**AMENDMENT NO. 6
TO
NUHOMS[®] COC 1004**

**ADDITION OF 24PHB DSC TO
STANDARDIZED NUHOMS[®] SYSTEM
NON-PROPRIETARY**

August 31, 2001
NUH03-01-1721

Subject: Application for Amendment No.6 of NUHOMS® Certificate of Compliance No. 1004 for Dry Spent Fuel Storage Casks, Revision 0

Figure 1-5
Heat Load Zoning Configuration for Fuel Assemblies (With or Without BPRAs)
Stored in NUHOMS®-24PHB DSC – Configuration 1

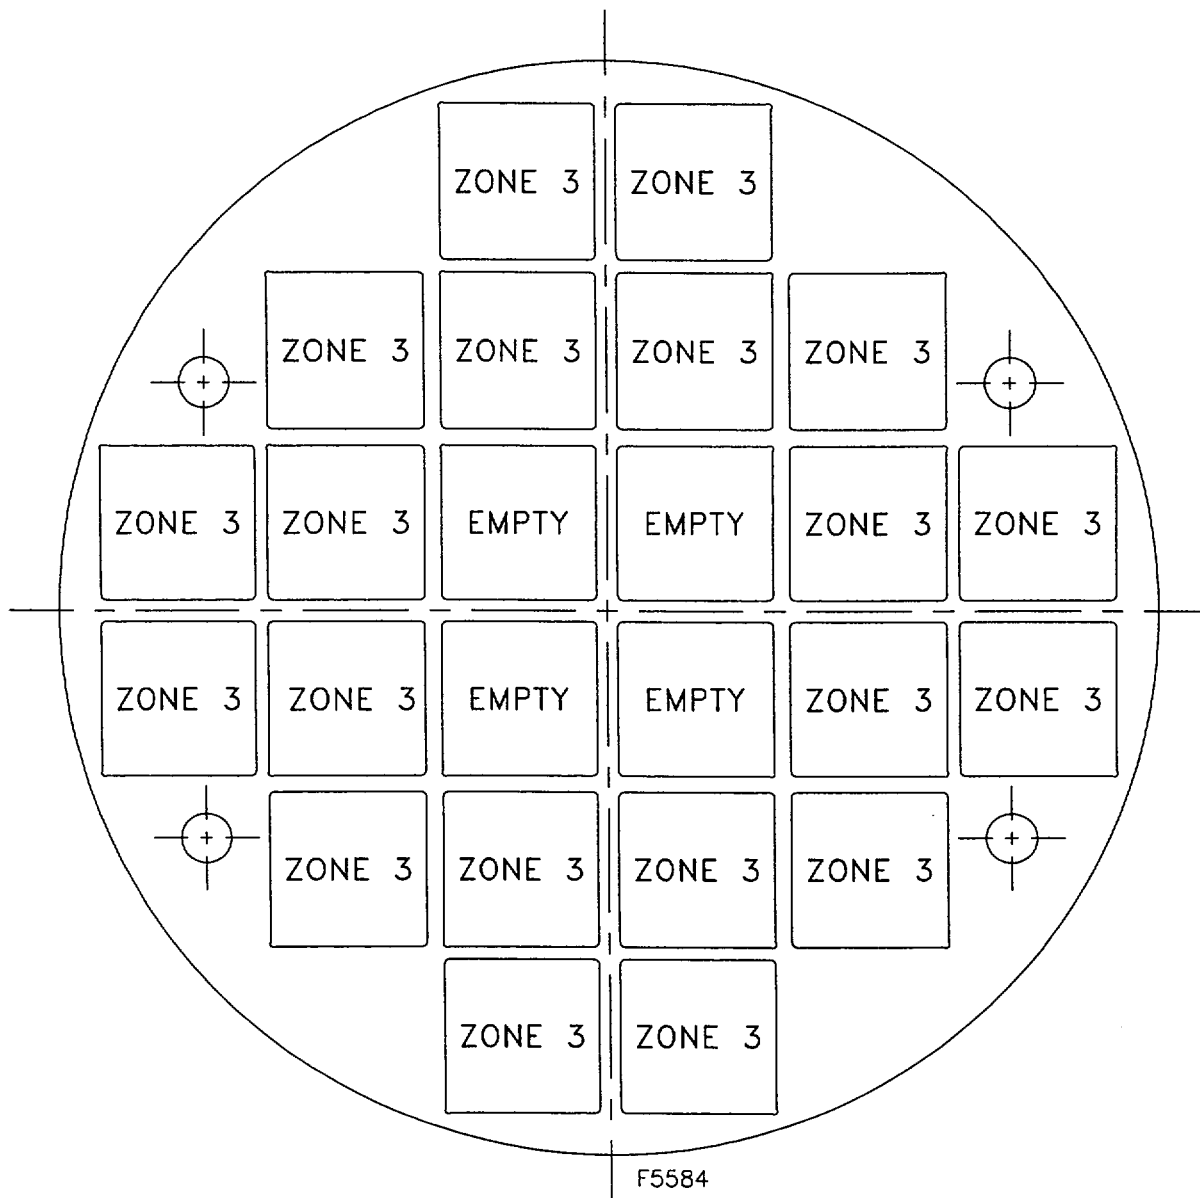
- Add Figures 1-5, and 1-6 to specify the two heat load zoning configurations analyzed for the 24PHB DSC.
- Revise the title and “Applicability” section of Specification 1.2.3a to extend the applicability of this specification to 24PHB DSC.

Figure 1-7
Soluble Boron Concentration vs. Fuel Assembly Initial U-235 Enrichment
for the 24PHB System

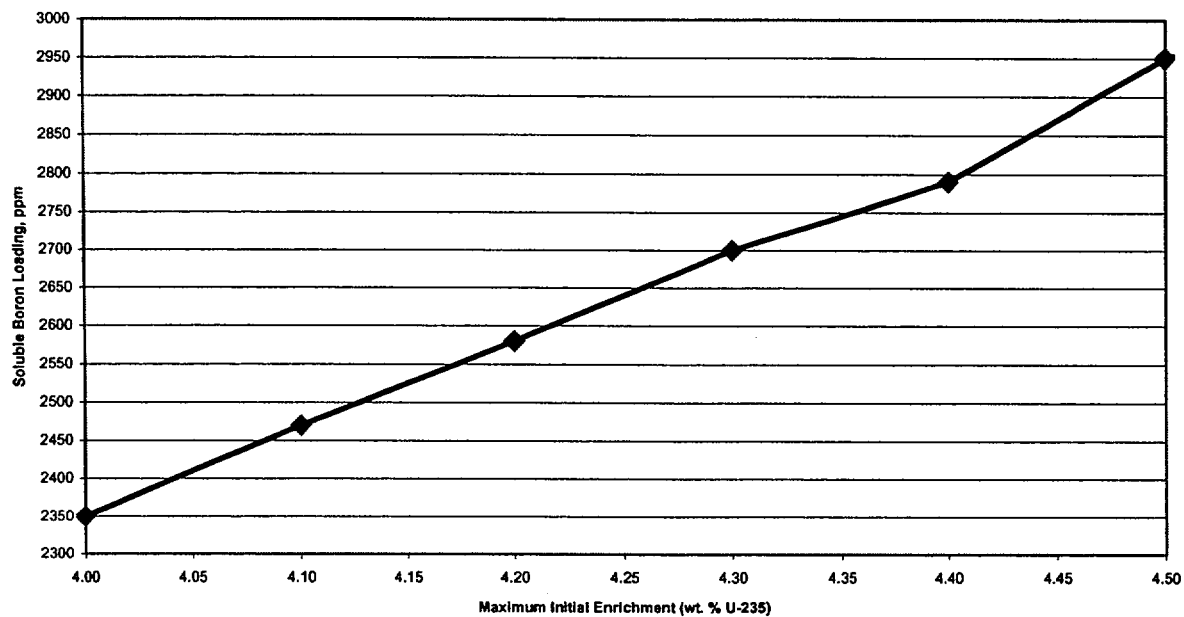
- Delete Specification 1.2.11, “Transfer Cask Dose Rates” since this is a redundant Technical Specification.
- Add a new Specification 1.2.15b and Figure 1-7 to specify the minimum boron concentration required during loading of the NUHOMS[®]-24PHB system.

- *The DSC cavity shall be filled only with water having a boron concentration equal to, or greater than 2,350 ppm for enrichment of less than or equal to 4.0 wt. % U-235 based on the spent fuel assembly with the maximum initial enrichment in the DSC.*
- *The DSC cavity shall be filled only with water having a minimum boron concentration per Figure 1-7 for initial enrichment of greater than or equal to 4.0 wt. % U-235 based on the spent fuel assembly with the maximum initial enrichment in the DSC.*

Figure 1.3-1
NUHOMS® Dry Shielded Canister Assembly Components

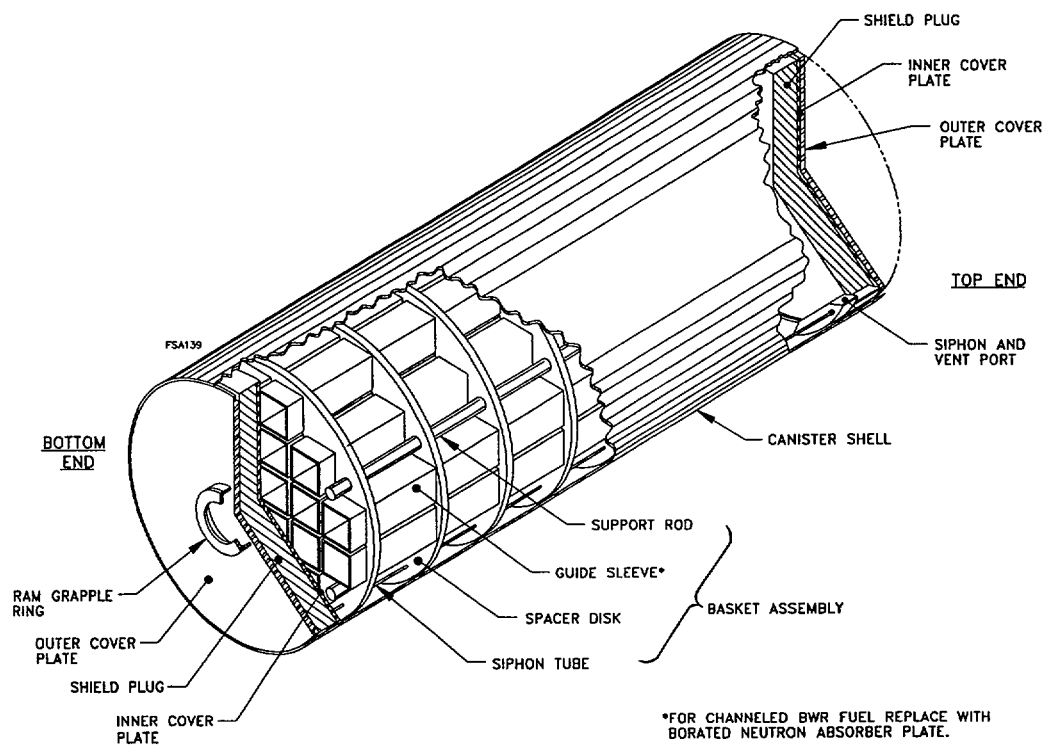
Note: Appendix N.1.5 shows the outer top cover plate and the test port plug details for the 24PHB DSC

Figure 4.2-5
DSC Siphon and Vent Port Closure Welds

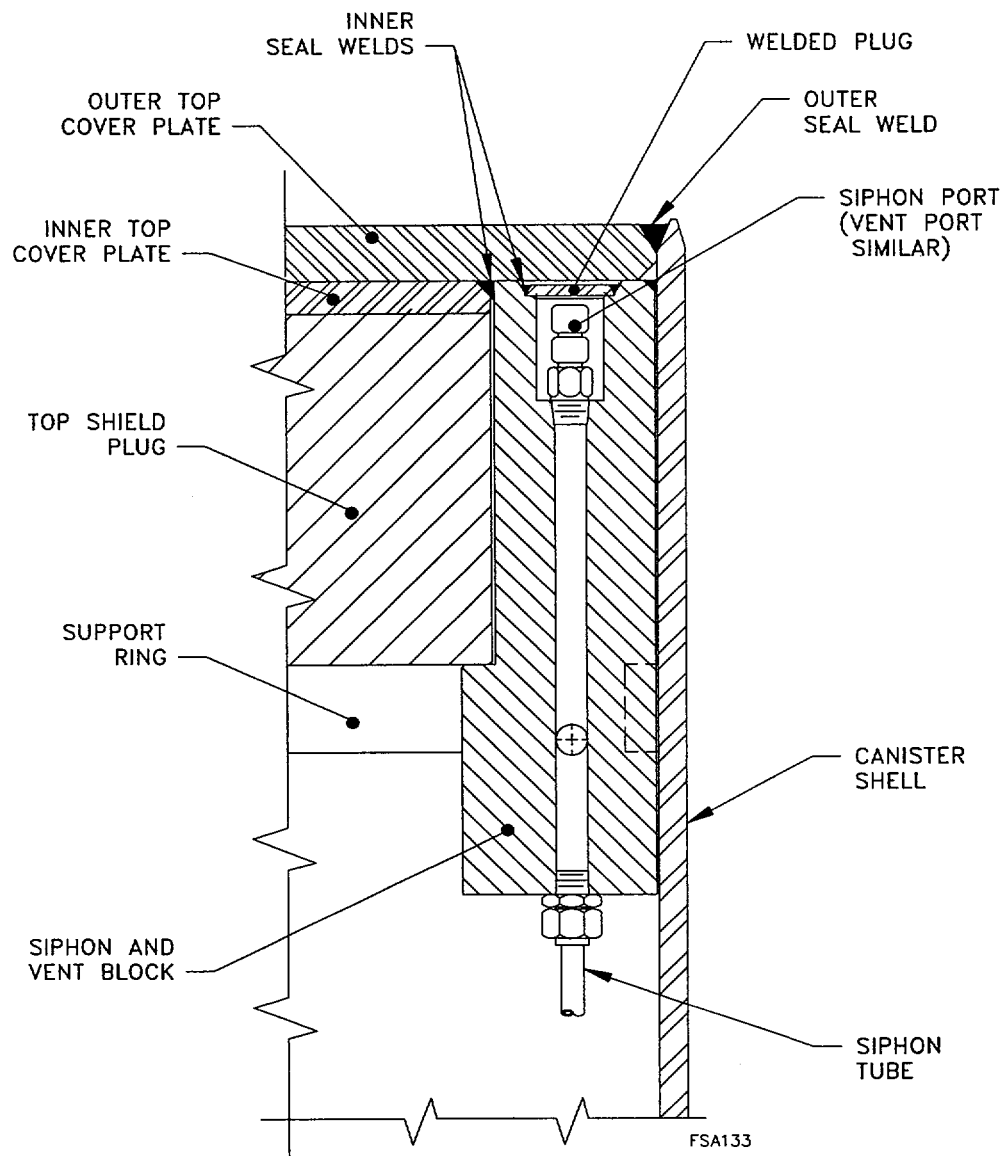
Note: For 24PHB DSC Outer Top Cover Plate and Test Port Plug Weld Closure Details, See Appendix N
